PART 21 INVOLVING DEFECTIVE SPRING CLIPS USED AS SEISMIC RESTRAINTS ON TWO SCIENTIFIC MODULES

Subject: 10 CFR Part 21 Report Notification, CON2000 and RTD2100 Spring Clips

Volume 38

Subject: CON2000 & RTD2100 Spring Clips

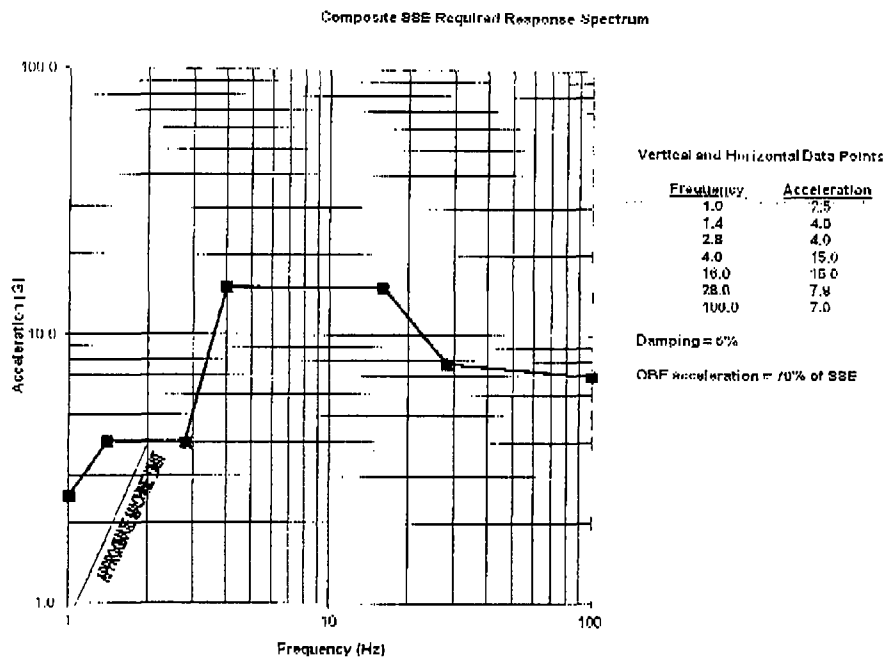
Investigation revealed that the original clip was made of 0.025" thick spring steel. After the seismic qualification test was performed, Revision 4 to NUS-I-089DB-13 altered the characteristics of the retaining clip, reducing the force required to disengage the detent. The metal was changed to SS301 stainless steel and the thickness reduced to 0.015" thick. Scientech's design change process required an evaluation of the impact on qualification; the evaluation was either not completed or not adequate.

These controllers could be mounted in the main control room control panels. The failure of the seismic clip could result in the controllers coming out of the panels, impacting other safety related equipment or personnel, and failing to properly control their actuated devices during a seismic event.

Scientech will provide 0.025" spring steel clips as used in the original qualification test with installation instructions to all affected plants. The spring clips are easily replaced in the field.
